FORM APPROVED  
OMB NO. 1004-0135  
Expires: July 31, 2010**SUNDRY NOTICES AND REPORTS ON WELLS**  
*Do not use this form for proposals to drill or to re-enter an abandoned well. Use form 3160-3 (APD) for such proposals.***SUBMIT IN TRIPLICATE - Other instructions on reverse side.**

NOBLE ENERGY RESPECTFULLY SUBMITS THE NOTICE OF INTENT TO PLUG AND ABANDON THE SUBJECT WELL, USING THE PROCEDURES ATTACHED.

### Manley 01-31

Re: Permanent Abandonment  
Well: 1-31 Manley

# Manley 01-31 Proposed P&A

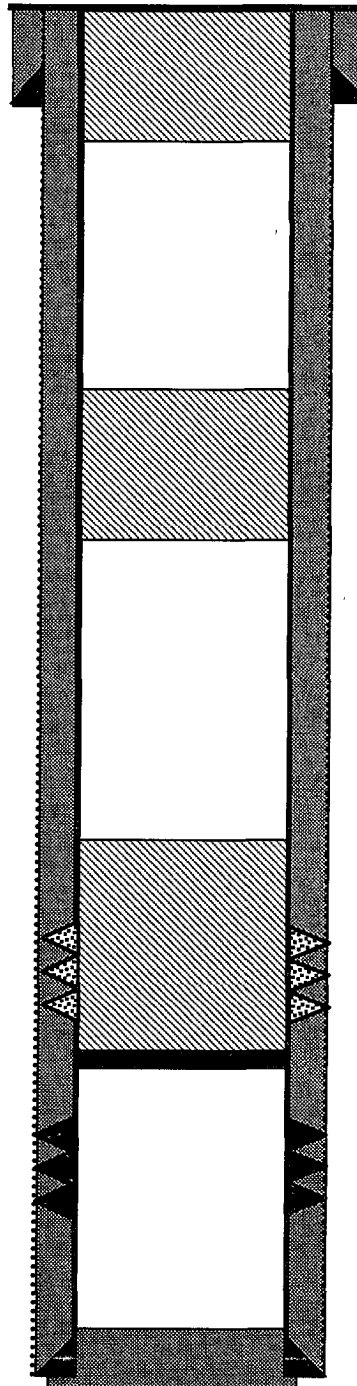
1. Plugging operations authorized are subject to the attached "General Requirements for Permanent Abandonment of Wells on Federal and Indian Lease."
2. Farmington Office is to be notified at least 24 hours before the plugging operations commence (505) 599-8907.
3. The following modifications to your plugging program are to be made:
  - a) Bring the top of the Pictured Cliffs/Fruitland plug to 1476'.
  - b) Place the Kirtland/Ojo Alamo plug from 856' –583'.

You are also required to place cement excesses per 4.2 and 4.4 of the attached General Requirements.
